V2500-A1/A5 SERIES PROPULSION SYSTEMS SERVICE BULLETIN

V2500-ENG-72-0458

<u>ENGINE - MAIN GEARBOX ASSEMBLY - INTRODUCTION OF REDESIGNED TRANSPORTATION PLUGS AND COVERS</u>

New EIPC Chapter 72-60-60 - External Gearbox Non-Modular Parts Figure 1

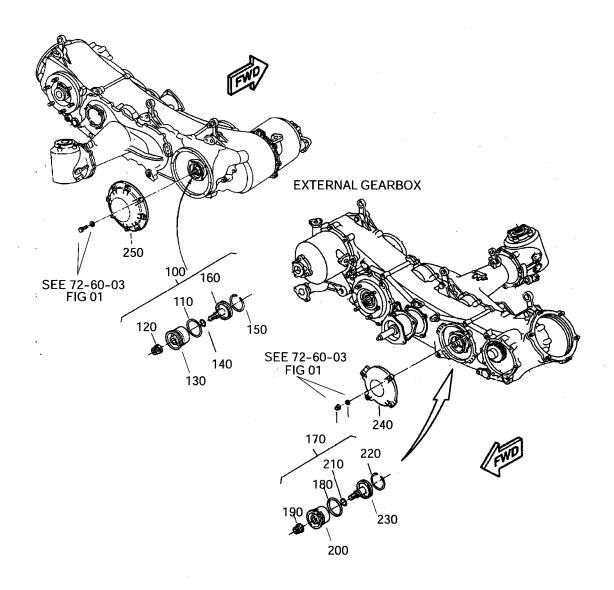
- (1) The changes introduced with this Service Bulletin are as follows:
 - (a) The IDGS Drive Plain Cover P/N 4P0140 (72-00-03, 01-060) Pre-SB ENG-70-0718 will be transferred in the new IPC Chapter 72-60-60 External Gearbox Non-Modular Parts, and used for engine test only. (See Figure 1).

- (b) The IDGS Drive Shaft Plug Assembly, P/N 4A0163 (72-00-03, 01-400) will be transferred in the new IPC Chapter 72-60-60 External Gearbox Non-Modular Parts, and used for engine test only. (See Figure 1).

- (c) The HYD Pump Plain Cover P/N 4P0139 (72-00-03, 01-090) Pre-SB ENG-70-0718 will be transferred in the new IPC Chapter 72-60-60 External Gearbox Non-Modular Parts, and used for engine test only. (See Figure 1).

- (d) The HYD Pump Shaft Plug Assembly, P/N 4A0138 (72-00-03, 01-290) will be transferred in the new IPC Chapter 72-60-60 External Gearbox Non-Modular Parts, and used for engine test only. (See Figure 1).

- (e) The IDGS Drive Plain Cover P/N 4G0086 (72-00-03, 01-060) introduced with SB ENG-70-0718 and made in sheet metal, will be deleted and replaced with a new Cover P/N 4G0089 made in plastic material and used for transportation only.
- (f) The Spacer P/N 4G0087 (72-00-03, 01-065) used with the IDGS sheet metal Cover, will be deleted.
- (g) The HYD Pump Plain Cover P/N 4G0085 (72-00-03, 01-090) introduced with SB ENG-70-0718 and made in sheet metal, will be replaced with a new Cover P/N 4G0088 made in plastic material and used for transportation only.
- (h) The Spacer P/N 4G0087 (72-00-03, 01-095) used with the HYD sheet metal Cover, will be deleted.
- (i) The Deaerator Plug P/N 7G0046-05 (72-00-03, 01-090) made in metallic material will be replaced with a new Plug made in plastic material.
- (2) Transportation of gearbox modules will be done with the new plastic covers.
